**TOWNSHIP OF GUELPH ERAMOSIA  
 PLANNING REPORT # 1**

**Application:** Zoning By-law Amendment  
**File No.:** ZBA 09/12  
**Date:** January 29<sup>th</sup>, 2013

**TO:** Township of Guelph/Eramosa Council, Janice Sheppard (CAO) & Gaetanne Kruse (Planning Administrator)  
**FROM:** Cuesta Planning Consultants Inc.  
**SUBJECT:** Zoning By-law Amendment Application (ZBA 09/12)  
 James Dick Construction Ltd. – Proposed Hidden Quarry

**APPENDIX A**  
**EXISTING FEATURES PLAN**

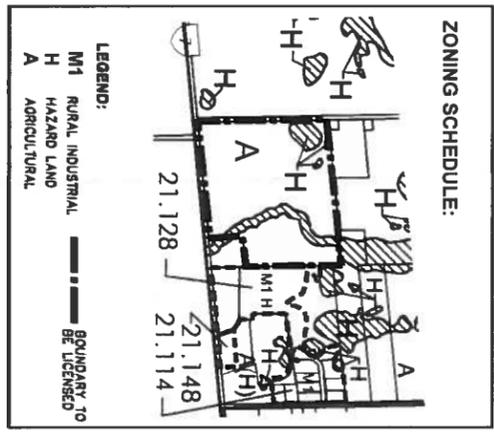
- The proposed entrance to be paved from the scale house to the public road.
- Will the existing service entrance shown on the Operations Plan remain or be removed?

- Fence/Gate geometry to be such that one full truck length can be off the travelled portion of the public road with the gate closed.
- Note 5 on the Operations Plan indicates that the existing property limits are fences although also indicates that fencing and repairs will be undertaken once extraction is initiated. An inspection of the existing fence condition is recommended to confirm the condition of existing fence and to establish the municipality's requirements in this regard.

- Top of rock elevation should be added to the Operations Plan.
- The Township's By-law Enforcement Officer should confirm the activities noted below conform to the Township's Noise Control by-law:
